Y1A, Y1B, Y1C- High-Voltage (HV) Battery Measurements during HV Battery Repair

Advanced Technical Information

Bulletin #: 2518.6

All Taycan HV batteries are subject to dielectric strength and insulation resistance (IR) testing after repair according to Workshop Manual WM 270803A5 Performing measurements on the high-voltage battery. In some cases, the VAS 6972 measurement equipment can report a failed Dielectric Strength test (DST) or the VAS 6558A can report a failed IR test. This bulletin serves two purposes. One is to provide an updated test procedure to more accurately isolate test failures, and the second is to serve as an updated diagnostic guide for interpreting the test results. Every safety warning and HV certification requirement from the Workshop Manual also applies to the work instructions contained in this document. Measurement specifications or component replacement requirement guidance listed in this bulletin take precedence over those stated in the Workshop Manual until this bulletin is removed or the workshop manual is updated.

Figure 1 - 28-module HV Battery measurement points

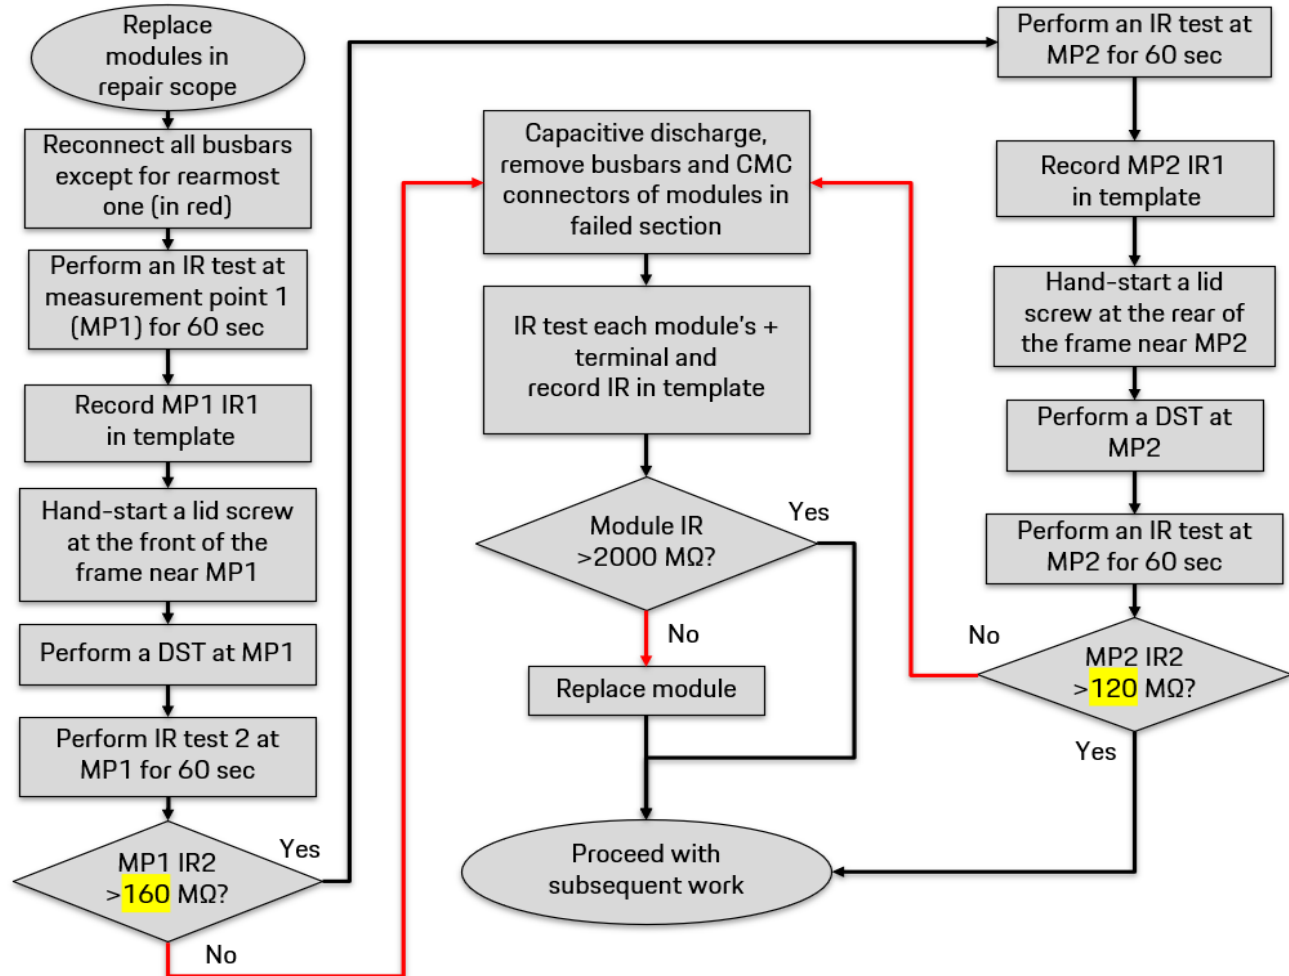
DST Procedure for 28-module Taycan Battery Pack (Figure 1)

- Only two DSTs are required on a 28-module battery pack during repair.
- The busbar indicated in red must be removed prior to measurements at either point.

- Perform an IR test at points 1 and 2 before the DST at those points.
- Perform a DST only at points 1 and 2 shown below for each repair scope.
- The yellow boxes in *Figure 1* designate the sections of frame where a lid screw can be hand-started to ground the dielectric strength tester.

- Also perform IR tests at points 1 and 2 after a DST, with the negative probe in contact with a clean spot on the silver frame surface designated by the yellow boxes.

- If the final IR test (IR2) at **measurement point 1** fails, remove busbars and CMC connections from each module shaded in **light blue** for further IR testing as described in the following *Updated IR Measurement Procedure* sections.

- If the final IR test (IR2) at **measurement point 2** fails, remove busbars and CMC connections from each module shaded in **light green** module for further IR testing as described in the following *Updated IR Measurement Procedure* sections.

- EXAMPLE: Point 1 passes DST and IR2 while point 2 passes DST but fails IR2.
 - Perform IR tests on each light green module in the failing section (In this example, section 2). No additional work is required for the passing modules in section 1.

Figure 3 - 33-module HV Battery measurement points

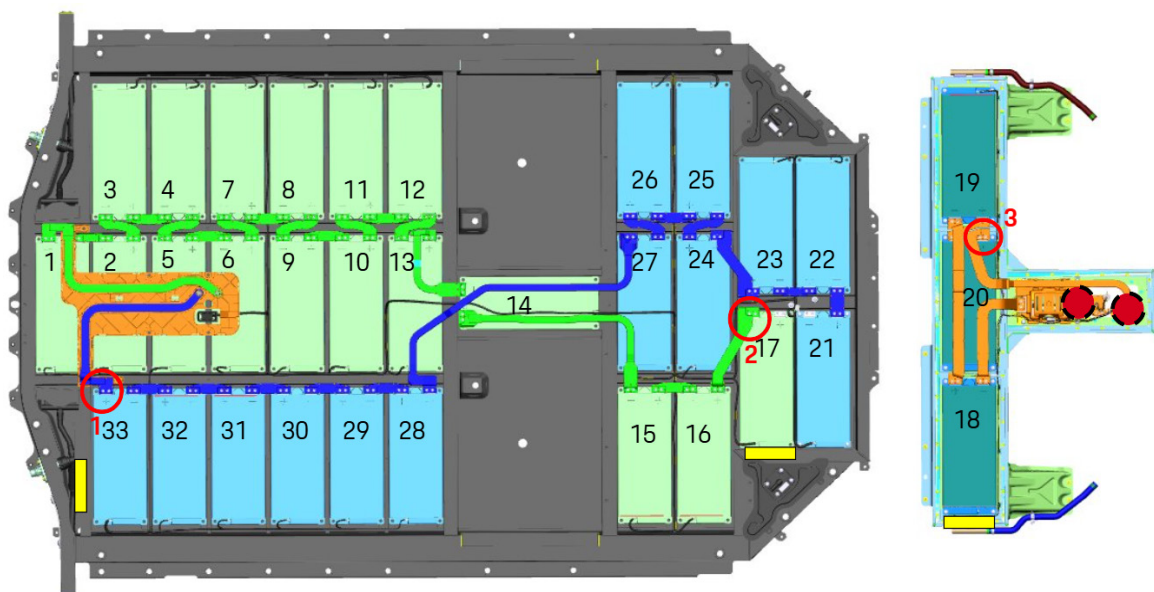
DST Procedure for 33-module Taycan Battery Pack (Figure 3)

- Only three DST's are required on the 33-module battery pack during repair.
 - Perform a DST at points 1, 2, and 3 for any repair scope involving the lower-level modules.

- Repair scopes in only the upper "T" section require an initial DST at the mid-pack fuse as shown in step 3.9.3 of Safety test after assembly work on the high-voltage battery with 33 modules in WM 270803A5 instead of point 3 in *Figure 3*.

- If removed, the upper "T" Section should be placed aside on a VAS 6762/44 Insulating mat during testing.
- Perform an IR test at points 1, 2 and 3 before the DST at those points.

- The yellow boxes in *Figure 3* designate the section of frame where a lid screw can be hand-started to ground the dielectric strength tester. If performing a DST on the mid-pack fuse, use the location on the upper "T" section to ground the negative clamp as described in the General DST Procedure Updates section.

- Perform IR tests at points 1, 2, and 3 after a DST, with the negative probe in contact with a clean spot on the silver frame surface designated by the yellow boxes.

- If the final IR test at **measurement point 1** fails, remove busbars and CMC connections from each module shaded in **light blue** for further IR testing as described in the following *Updated IR Measurement Procedure* sections.

- If the final IR test at **measurement point 2** fails, remove busbars and CMC connections from each module shaded in **light green** for further IR testing as described in the following *Updated IR Measurement Procedure* sections.

- If the final IR test at **measurement point 3** fails, remove busbars and CMC connections from each module **in the upper "T" section** for further IR testing as described in the following *Updated IR Measurement Procedure* sections.

- **EXAMPLE:** It is possible for battery to have point 1 pass, point 2 pass, and point 3 fail the IR2 measurement. It would then only be required to perform further IR tests on each module in the upper "T" section. No additional work would be required for the passing lower sections.

Figure 4 - 33-module Lower Section Flowchart

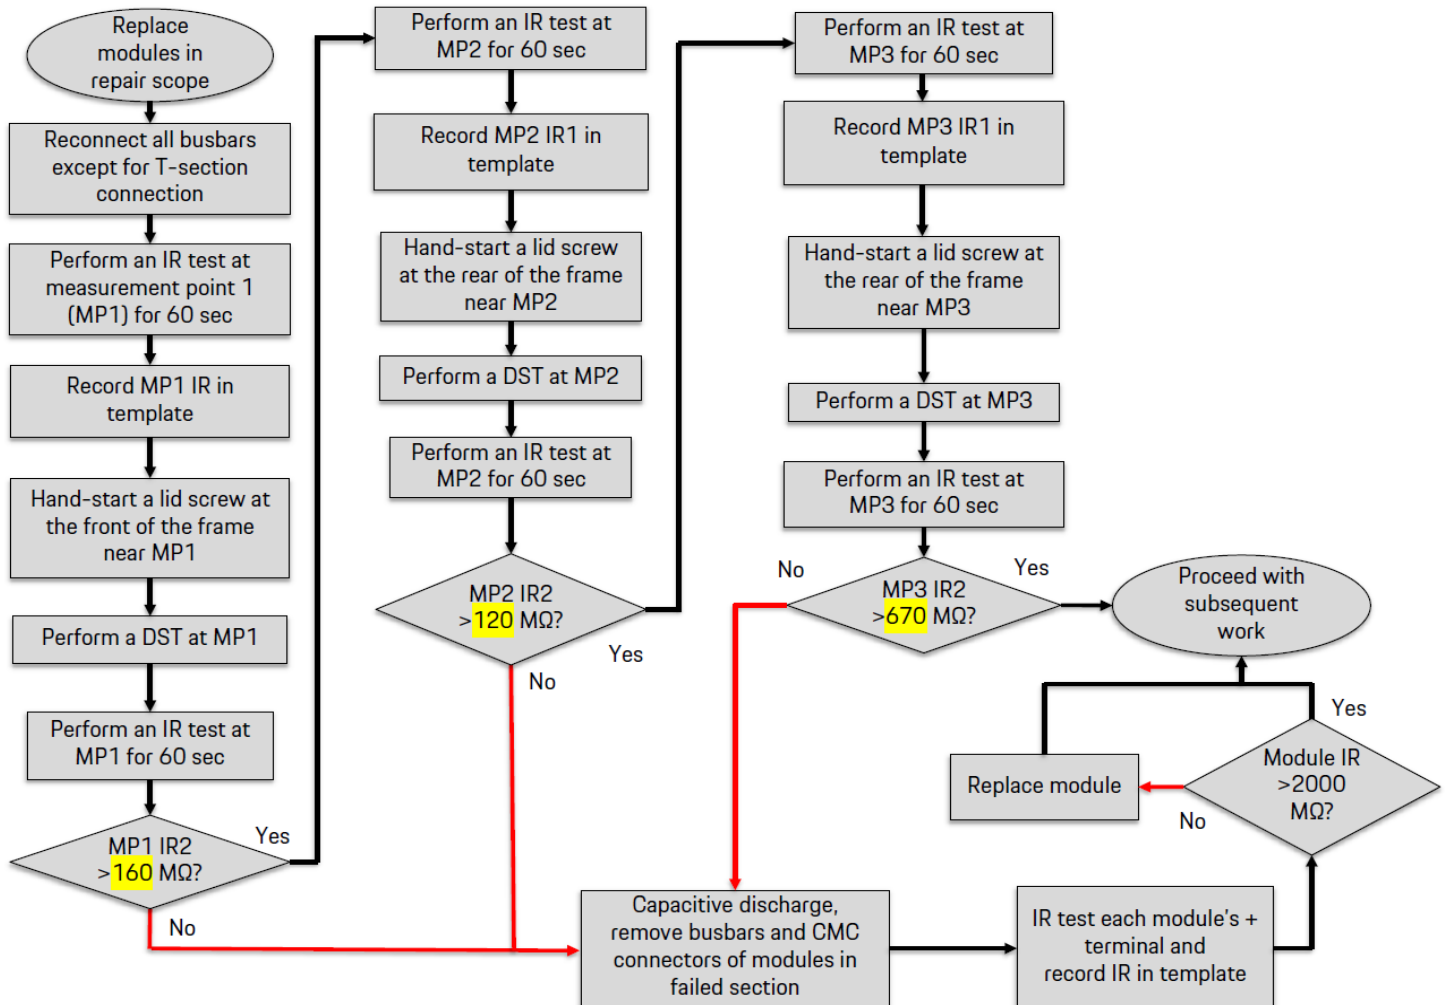
- Perform IR tests at each measurement point in *Figures 1* and *3* before and after a DST at that point.
 - If the DST passes but IR falls below the thresholds in *Figures 2, 4, and 5*, proceed with IR testing each module.

Figure 5 - 33-module Upper Section Flowchart

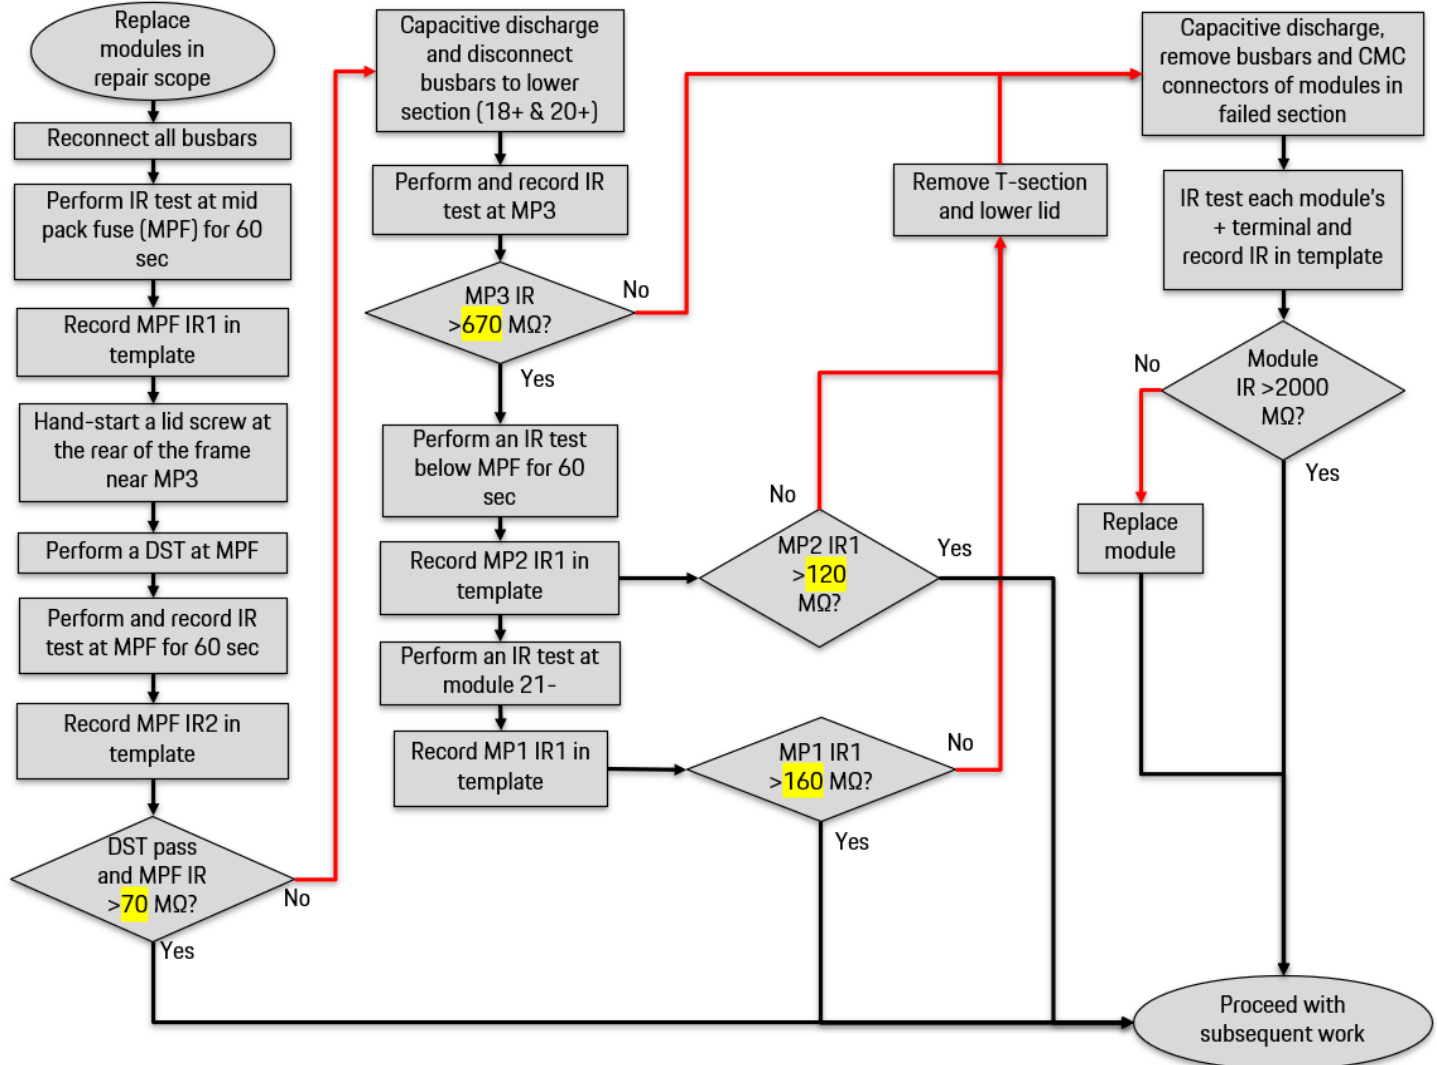
- If the DST fails but all modules in the section pass IR, proceed with the repair.
- For repair scopes only in the upper level, IR test the upper and lower sections separately after an initial DST failure according to the flowchart in *Figure 5*.

- These measurement points identified below the mid-pack fuse in *Figure 3* serve as alternates to MP1 and MP2 as referenced in the *Figure 5* flowchart when the lower lid is still installed.

Figure 6 - IR Test at Positive Terminal

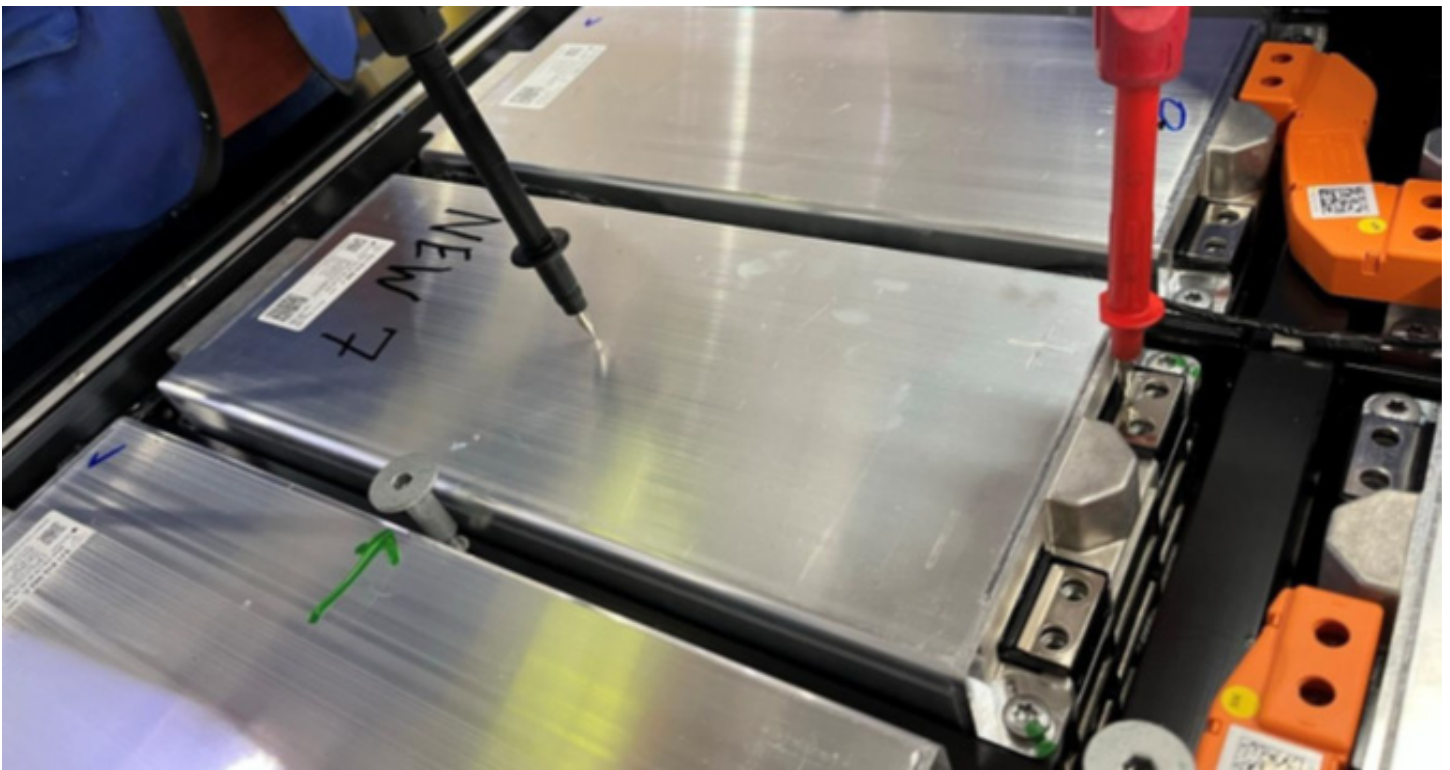
Module IR Testing Procedure: Positive Terminal (Figure 6)

- **WEAR CERTIFIED HV GLOVES** for your safety and the accuracy of the measurement.
- Place the red probe at the edge closest to the black plastic surrounding the terminal to avoid scratching the conductive surface.
 - ▷ CAUTION: pay attention to the angle of the red probe in this case. Avoid contact with the side of the probe and the edge of the module housing. Use a plastic probe cap to expose only the tip of the probe if available.
- Maintain contact with the black probe to the module case in the center. Ensure that the module casing surface is clean at the point of contact.
- The equipotential bonding cable is not suitable as a ground point during this test. Use both straight probes directly on the module to isolate conductive influences.

Figure 7 - Insulation resistance measurement in PIWIS Tester

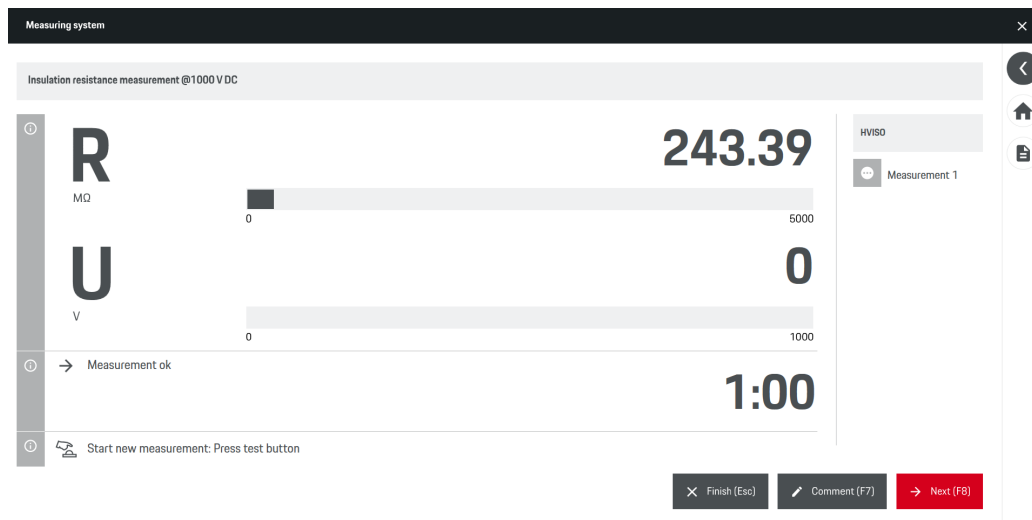
IR Testing Pass/Fail Criteria (Figure 7)

- Shown below is an example of passing test result for section 1 or 2 after 60 seconds of measuring time. This reading can still be displayed as >5000 MΩ when IR measures above the internal software measuring threshold.
- If any individual module terminal IR test shows a number below 2000 MΩ after 60 seconds of continuous measuring time, this is considered a failure.
 - If more than 5 modules in a failing section measure below 2000 MΩ, submit the completed Taycan HV Battery Insulation Resistance Template to Technical Support via PRMS.
- If IR is below the minimum measurement threshold, the IR test won't complete in the measurement equipment display. If the IR test fails to produce a value after multiple attempts on any module terminal, replace it.
- Document any failures in the "Taycan HV Battery Insulation Resistance Template" Excel file attachment and attach to the repair PCSS entry.
